Australian Air Publication 721.79

ROYAL AUSTRALIAN AIR FORCE

VAMPIRE MODIFICATIONS

(Nos 1 to 100)

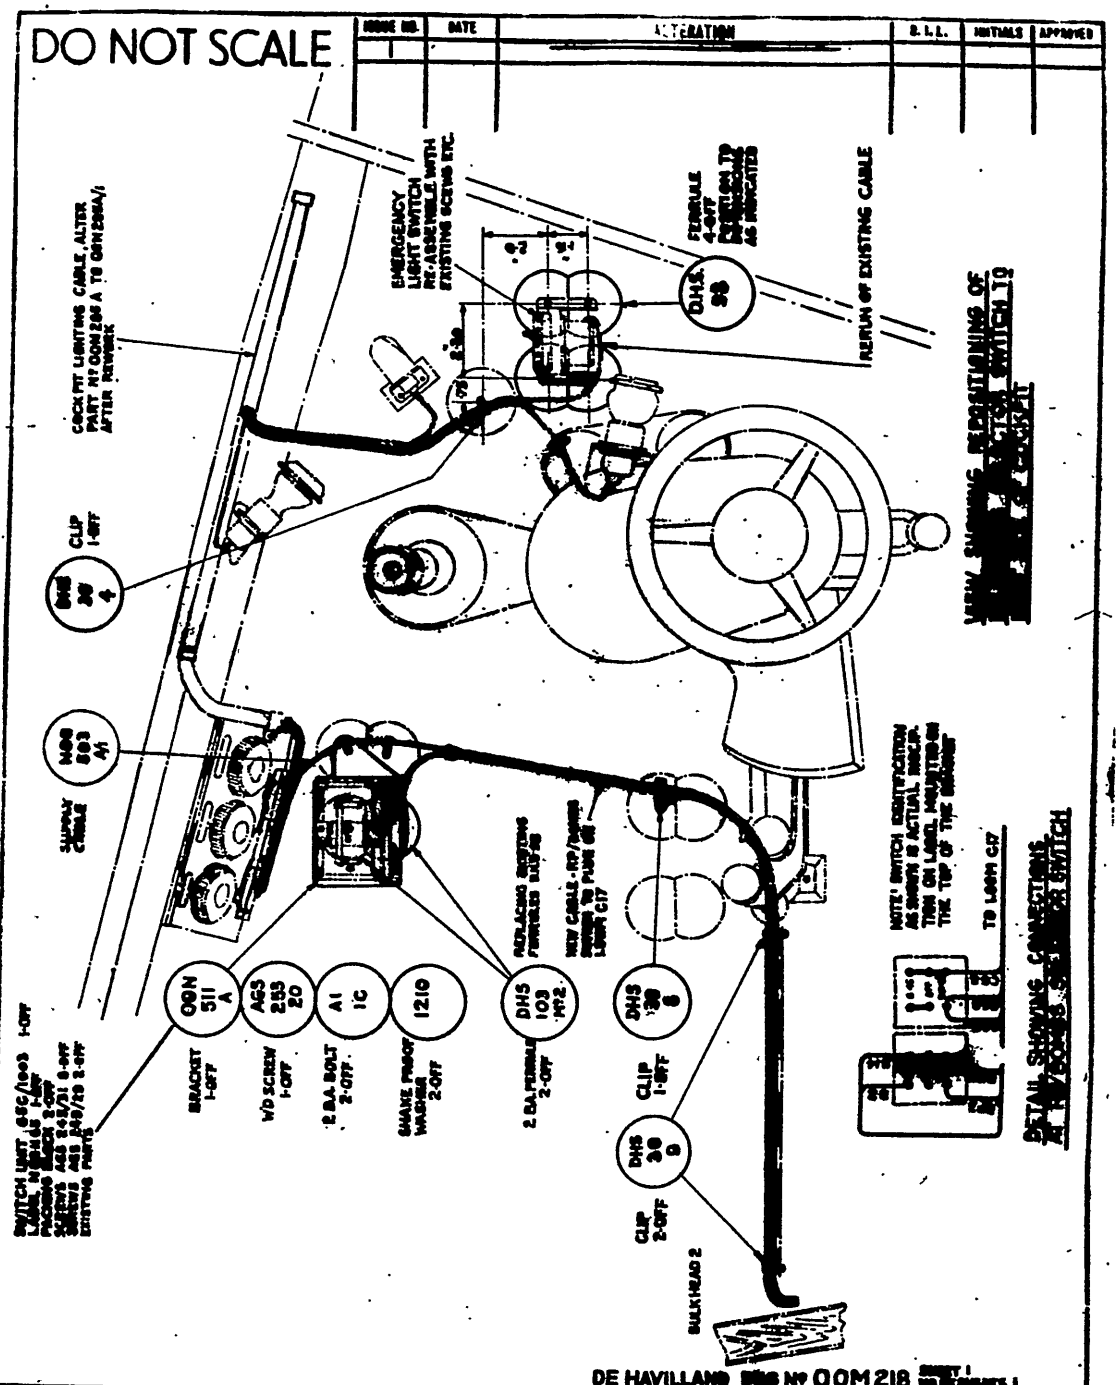
25. Whip the supply cable together with the new cable of conduit C17 along bulkhead No.2, and attach both the cables to the left hand cockpit side, as shown on the drawing No.G11928 SHEET 1 using new cable clips (item 11 & 12) and the cable clip retained in paragraph 14. A.L.16

DE HAVILLAND DRG. Nº 00M218 SHEET: 2 OF SHEETS: 2.

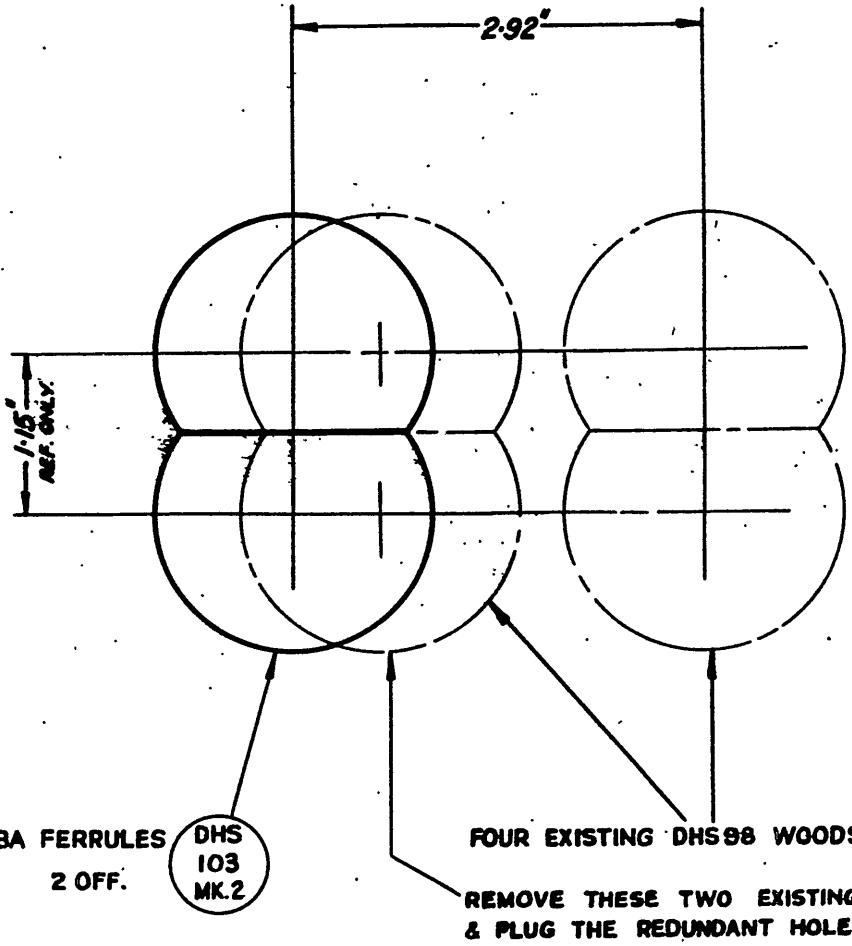
13. Refer to drawing No. G11928, SHEET 2. A2 16 and remove and discard the two emergency switch woodscrew ferrules nearest to bulkhead No.2 (item 23), retain the cable clip attached to the lower ferrule.

DETAIL SHOWING MOD. TO FERRULES FOR ATTACHMENT OF RP/BOMBS SW.

DE HAVILLAND DRG. Nº 00M215

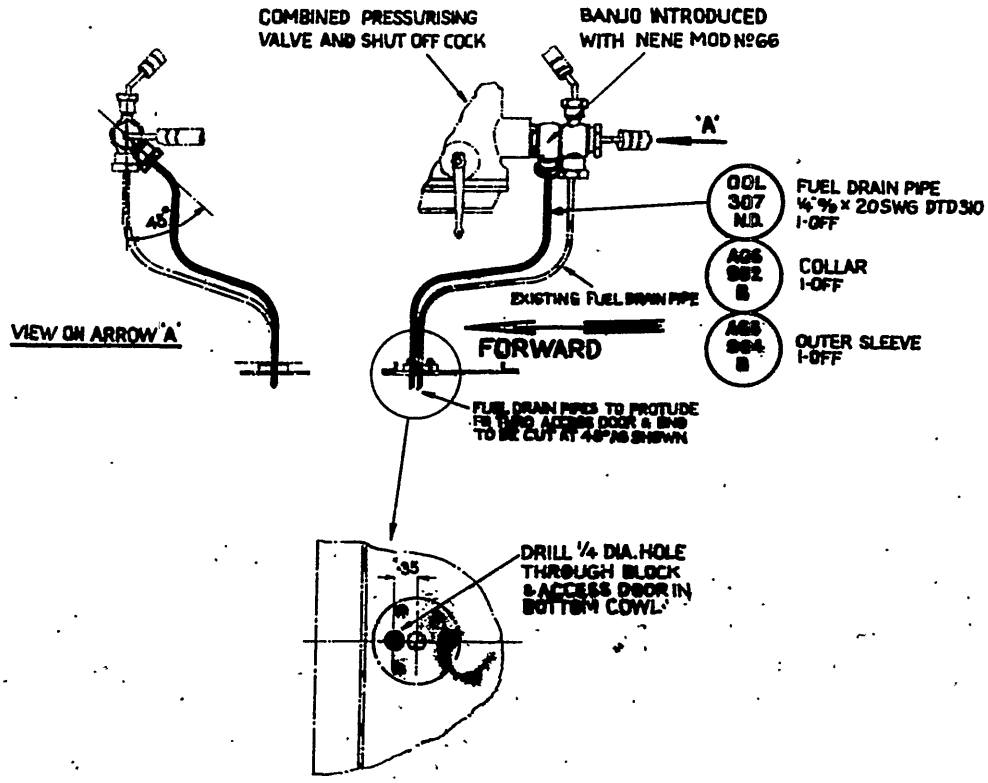
(a) Refer Drawing All938, locate the new fitting on the shut off cock and attach the new drain pipe (item 1) in the position as shown on the drawing, using attaching parts (items 2 and 3). Wire lock using item 4.

NOTE: THIS MODIFICATION IS TO BE CARRIED OUT IN CONJUNCTION WITH NENE MOD. Nº 66

DE HAVILLAND DRG. N° **OOM233** SHEET N° 1 OF N° OF SHEETS 1

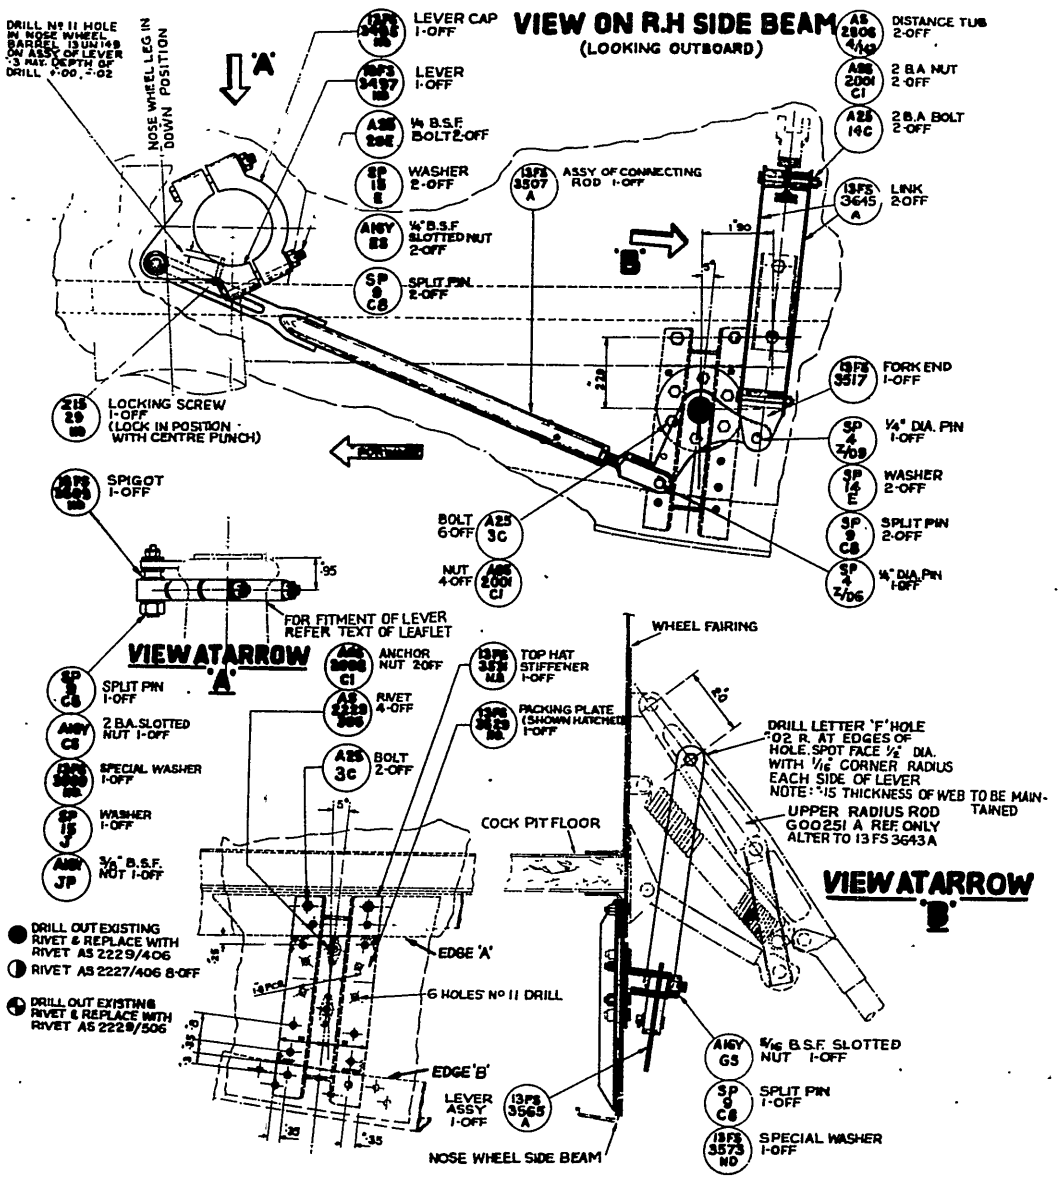
(b) Refer drawing A11983 and carefully measure the position of the new lever bearing on the inboard face of the nosewheel housing sidebeam in accordance with the dimensions shown.

(m) Disconnect and remove the upper radius rod from the nosewheel door operating mechanism, Retain all the securing items but discard the split pins (item 37). Refer drawing A.11983, mark off and drill a letter 'F' hole on the centreline of the radius rod 2" from the centre of the upper securing hole. Spotface the surface around the hole. Replace the radius rod using split pins (item 17) where required.

DE HAVILLAND DRG. Nº 00M 234 SHEET 1 OF SHEETS 1

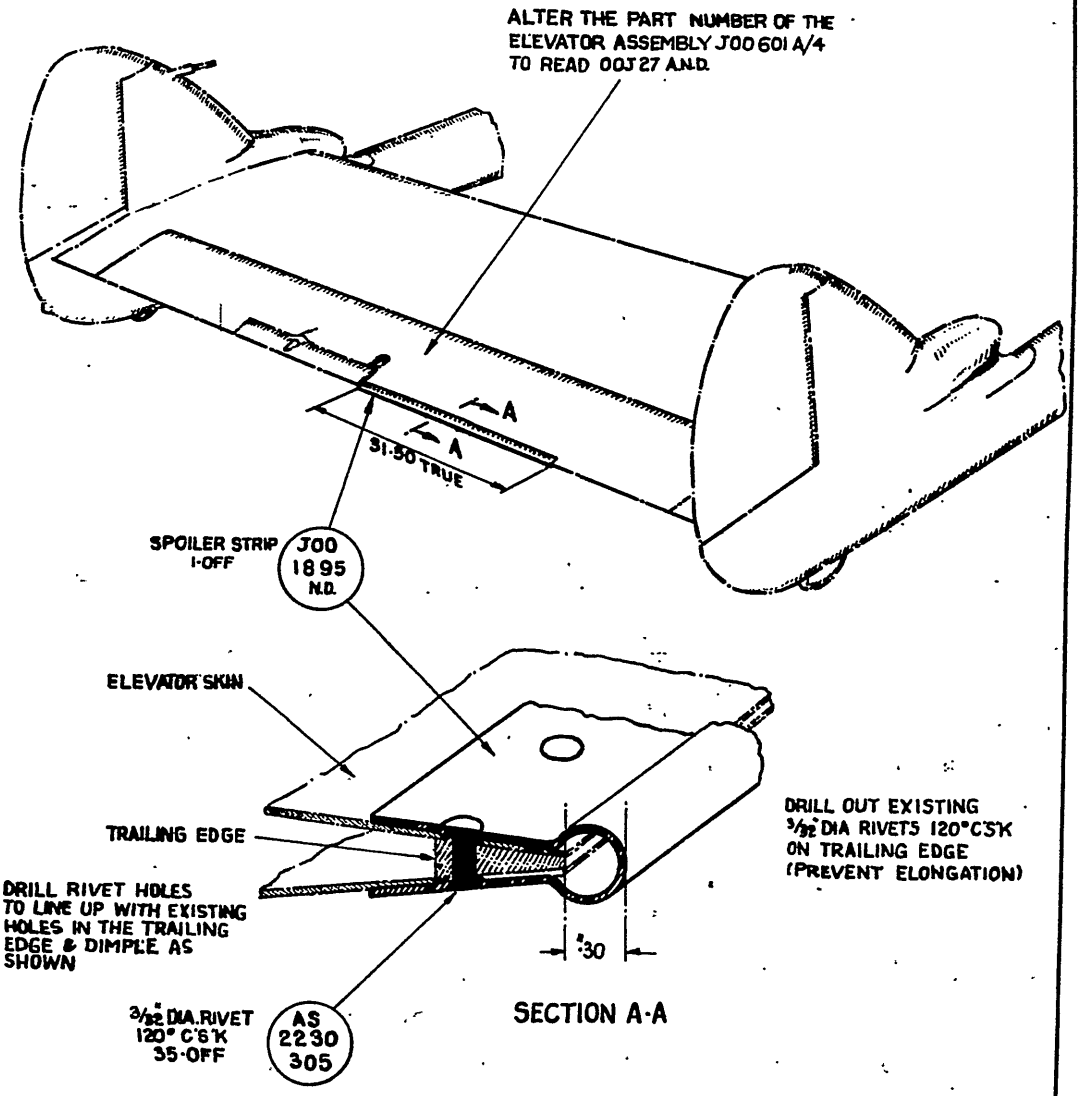
(c) Refer drawing A.11966 and position the new spoiler strip as shown. Mark off and drill rivet holes to line up with the existing holes in the trailing edge.

DE HAVILLAND DRG Nº 00M 207

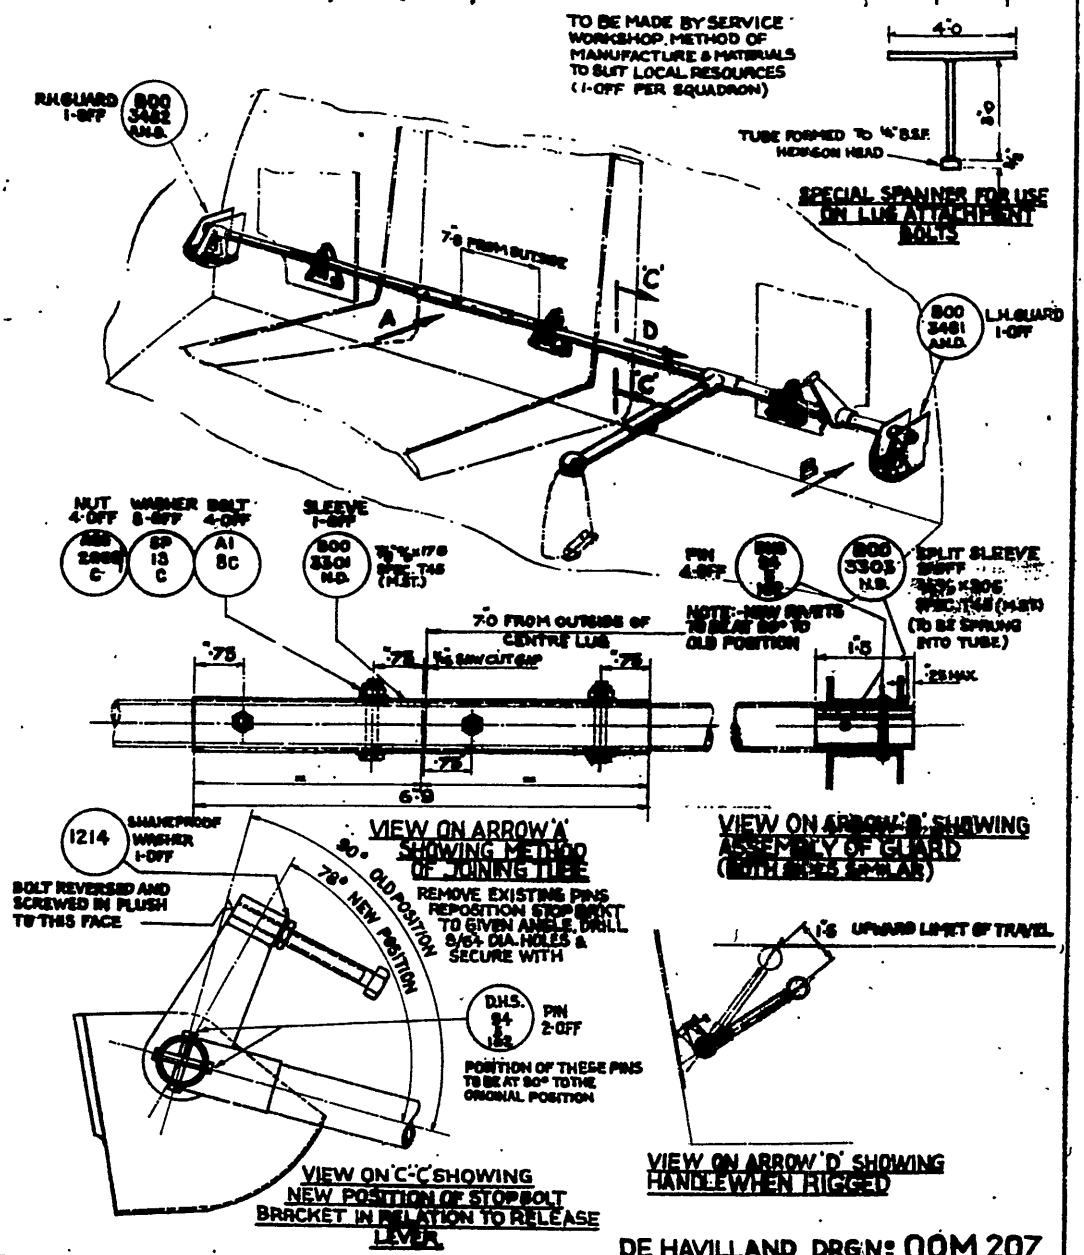
(d) Mark off and saw the shaft in two, (see dimensions on drawing A-11973).

(e) Remove and retain the nine fixing bolts securing the torque shaft to the bulkhead. Use the special spanner detailed on drawing A11973 which is Unit Manufacture.

(g) Refer drawing A11973. To ensure correct alignment on reassembly, scribe a line along the quadrant and tube at each end. Proceed now to carefully file off the ends of the pins securing the quadrants to the shaft and gently punch out to free.

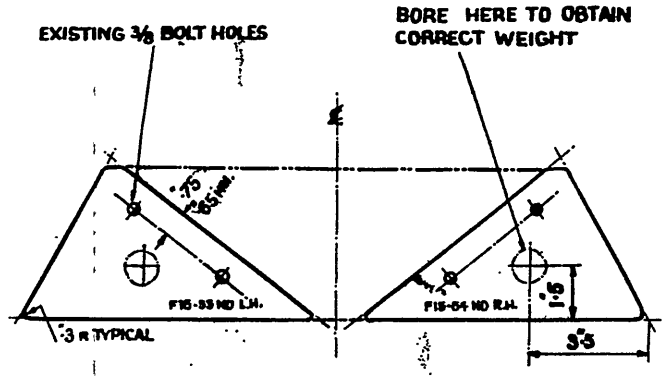
EXISTING BALLAST WEIGHT F15-33 N.D. (60 LB)
TO BE CUT AS SHOWN TO MAKE TWO WEIGHTS
EACH COMPRISING 15 3/4 LB ± 4 OZ.

RE PART NUMBER TO F15-53 N.D. L.H
& F15-54 N.D. R.H
